ITEM 7.0

CONSIDERATION OF OPTIONS WHICH MAY INCREASE THE NORTHERN SETBACK OF THE TOP LEVEL OF THE BUILDING.

1600MM HIGH SHELF ANGLES

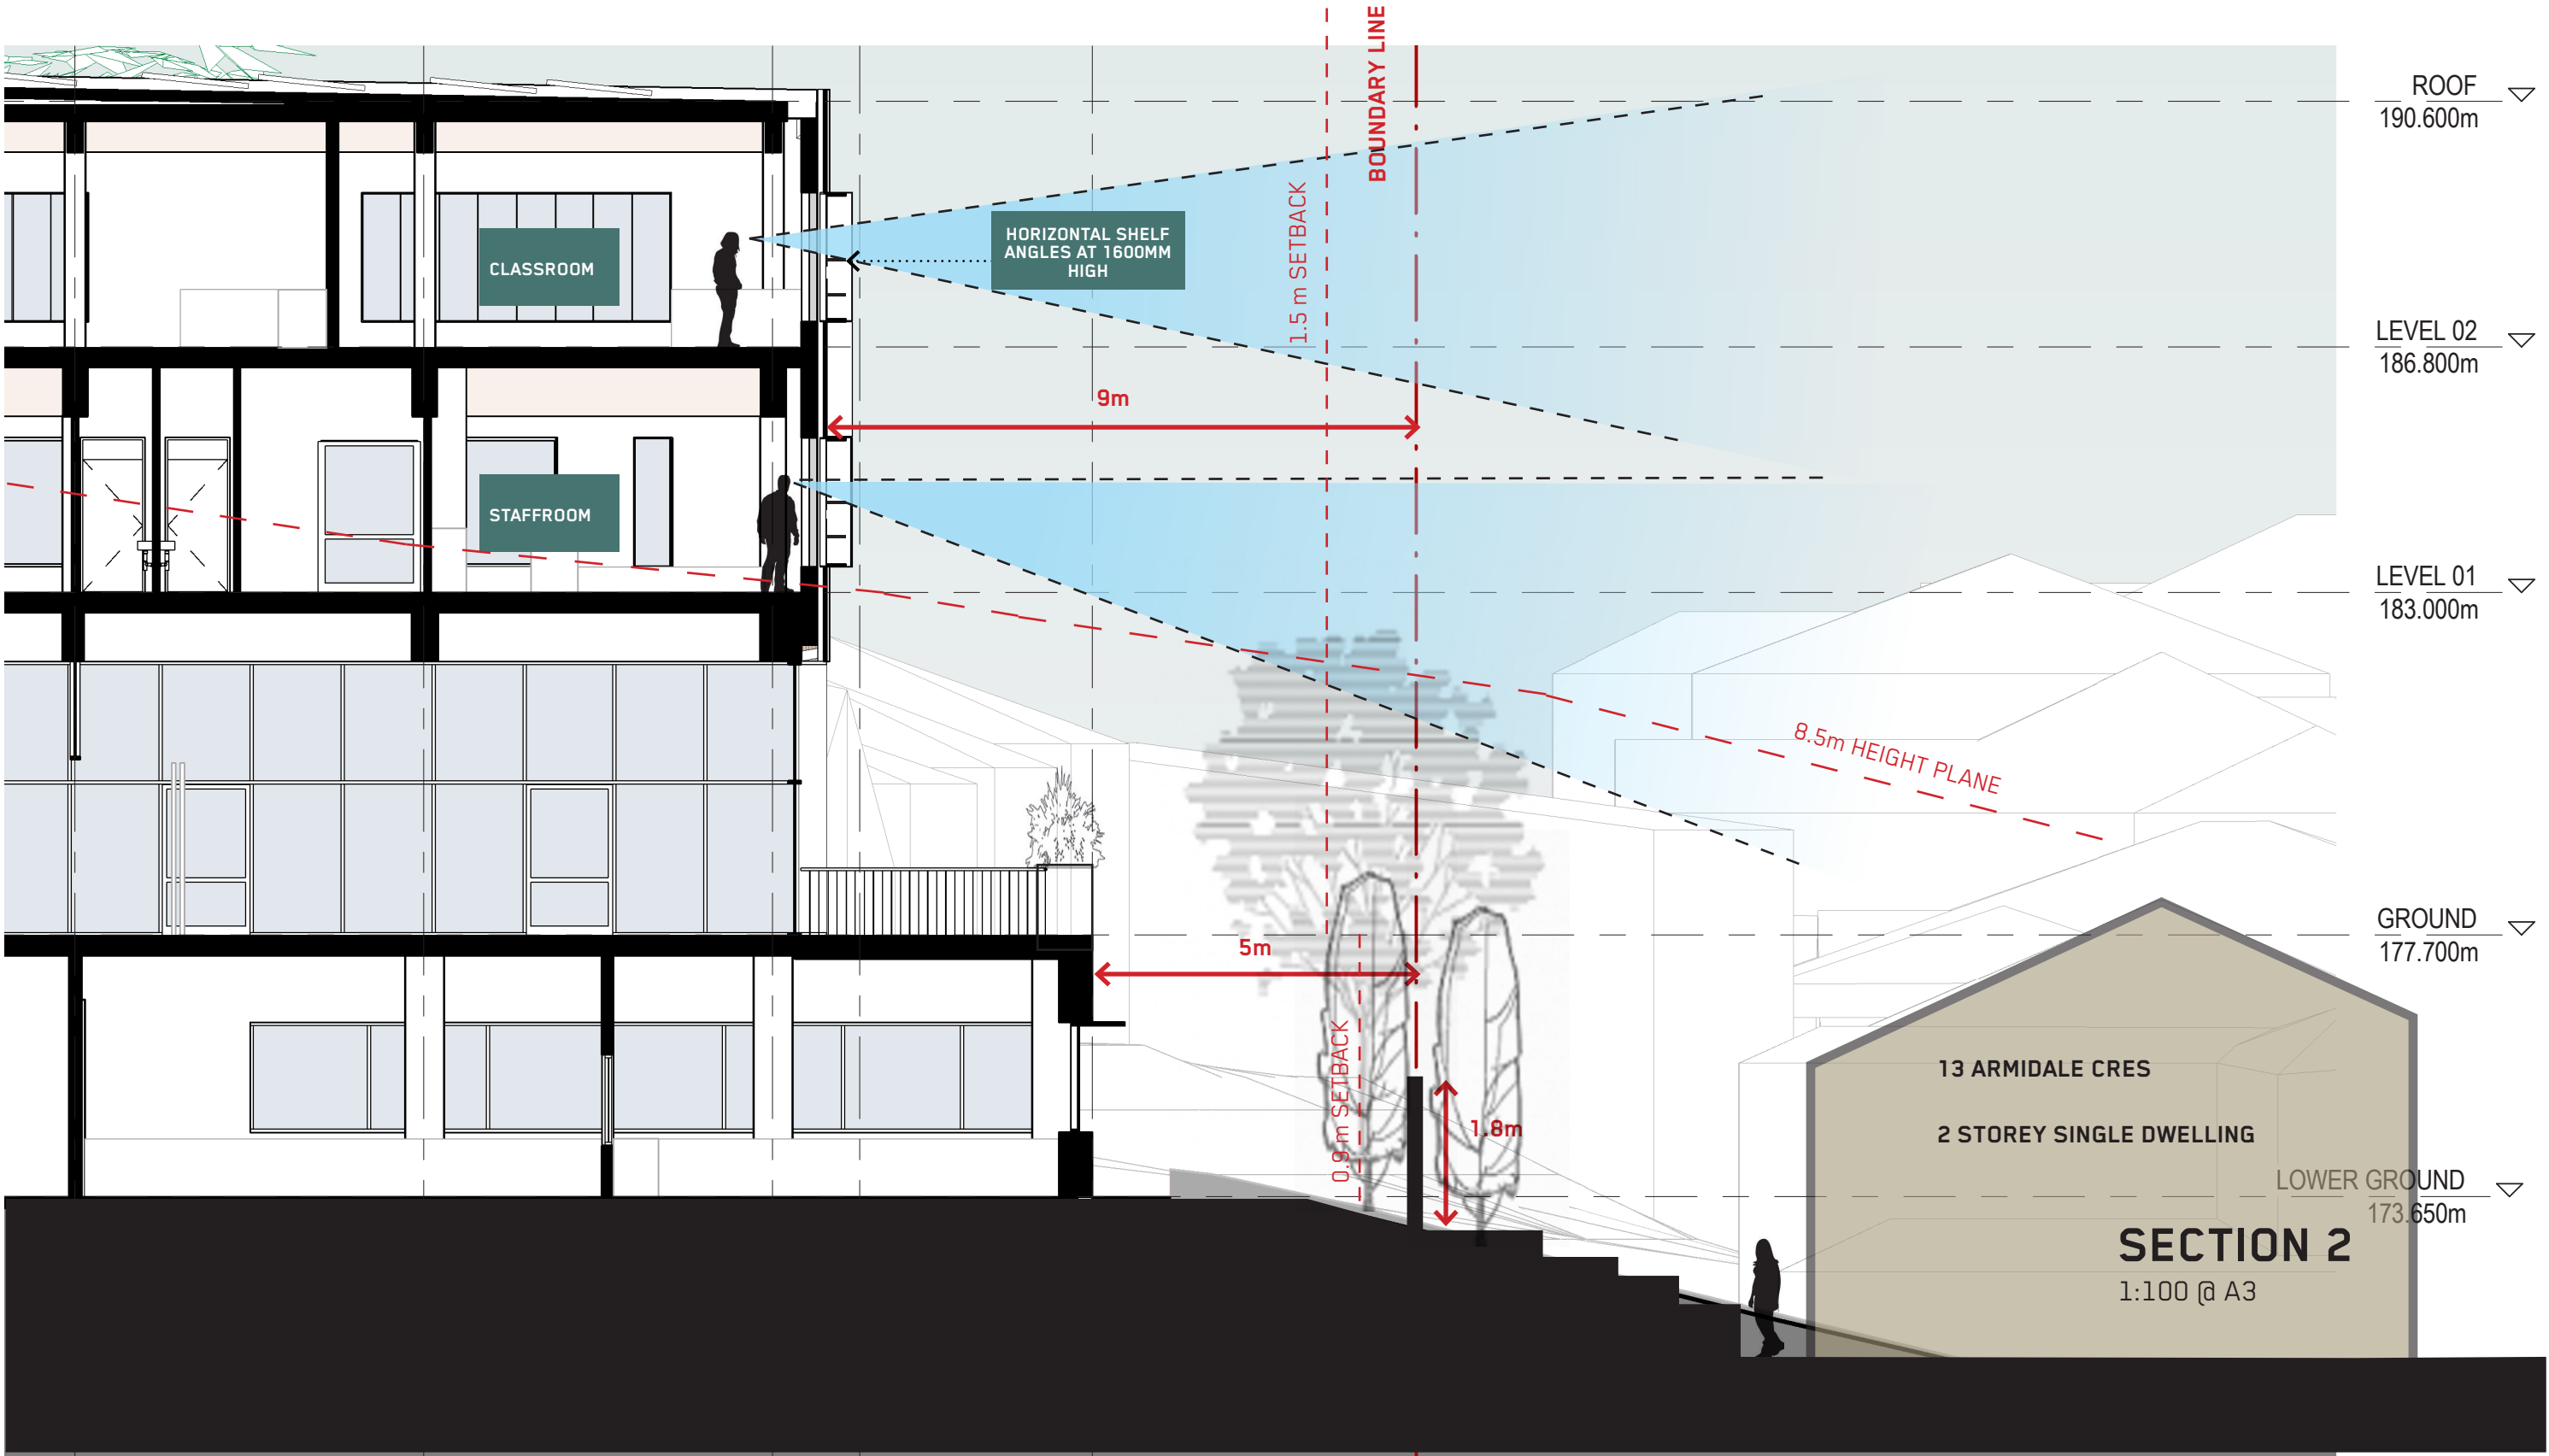
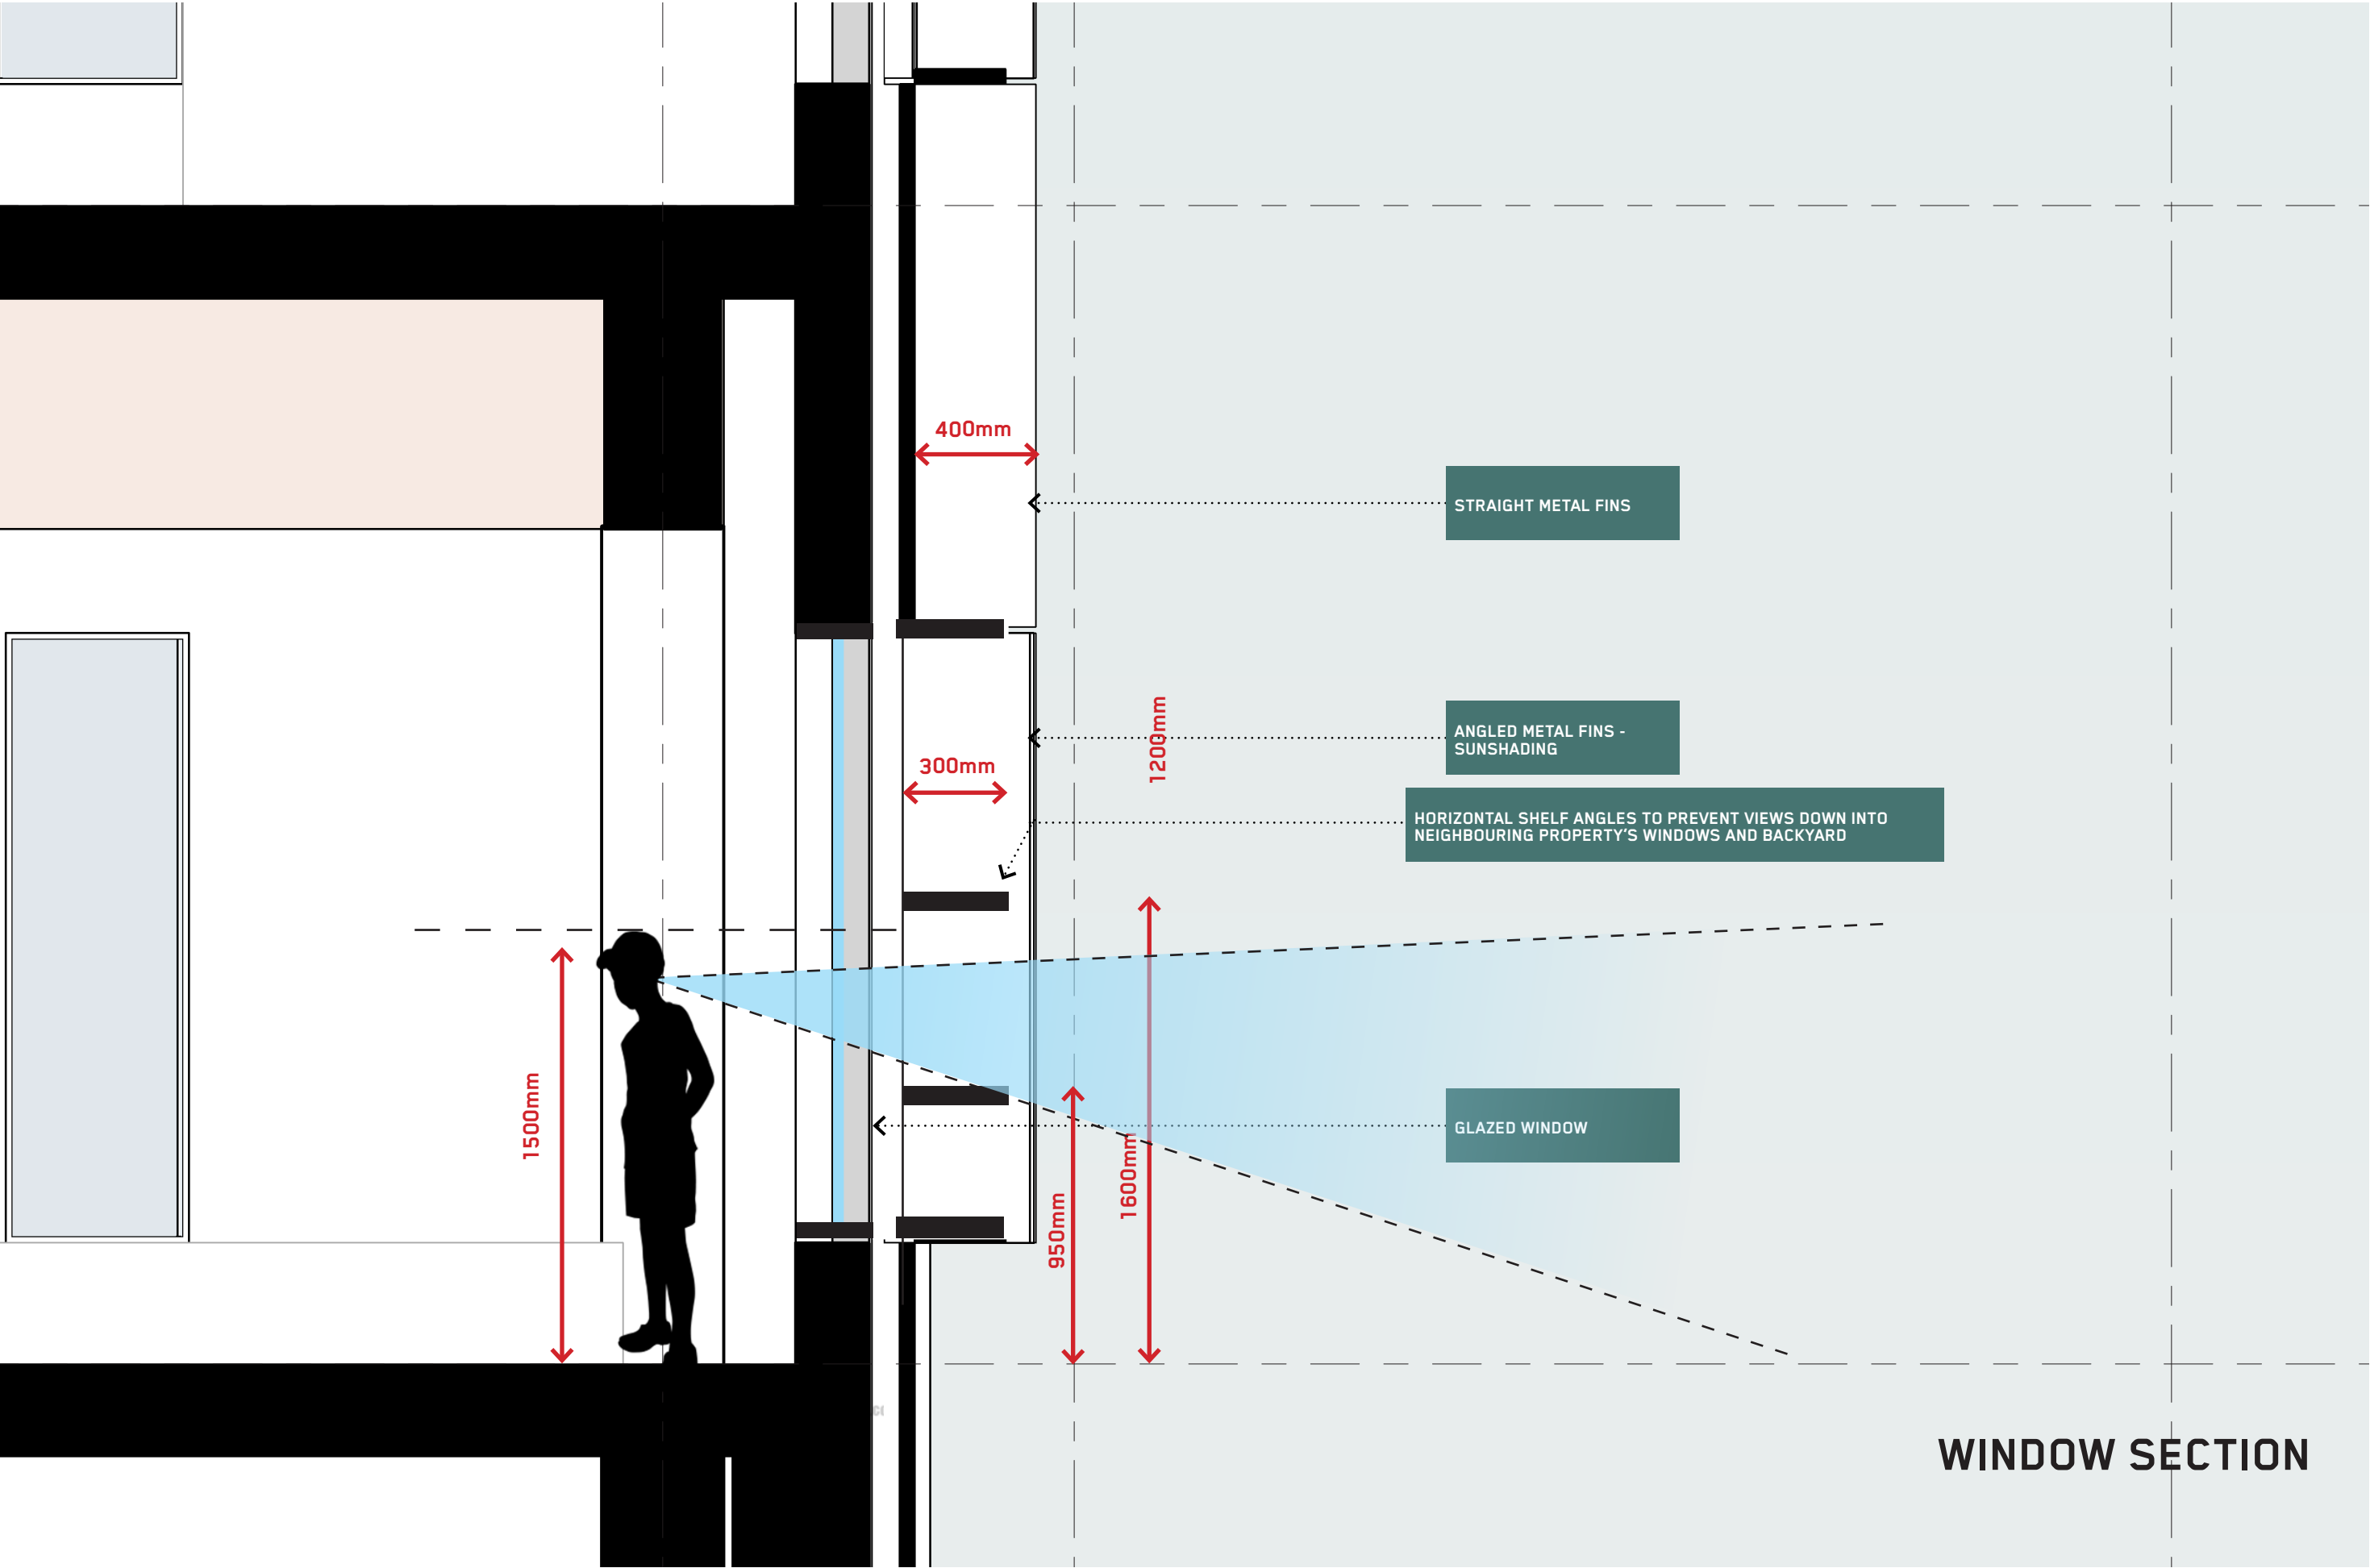
- INCREASING THE NORTHERN SETBACK WILL HAVE NO ADDITIONAL VISUAL IMPACTS DUE TO THE USE OF HORIZONTAL SHELF ANGLES
- SHELF ANGLE WILL PREVENT VISUAL LINE INTO THE NEIGHBOURING PRIVATE OPEN SPACE AT 9M SETBACK, NORTHER WINDOWS MAIN PURPOSE IS TO ALLOWING SUNLIGHT INDRECT INTO CLASSROOM SPACES.
